Seabrook Station

License Amendment Request 13-02

Application to Revise Technical Specifications to Adopt TSTF-510, "Revision to Steam Generator Program Inspection Frequencies and Tube Sample Selection," Using the Consolidated Line Item Improvement Process

3/4.4.5 STEAM GENERATORS (SG) TUBE INTEGRITY (Continued)

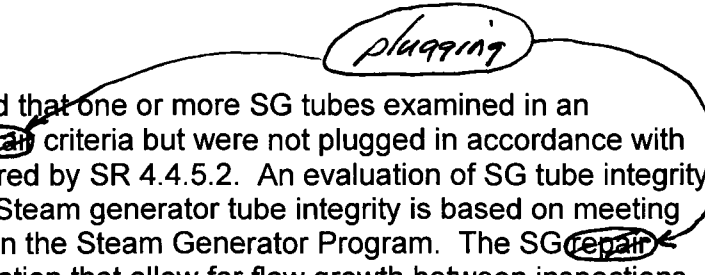
Steam generator tube integrity is challenged when the pressure differential across the tubes is large. Large differential pressures across SG tubes can only be experienced in MODES 1, 2, 3, or 4.
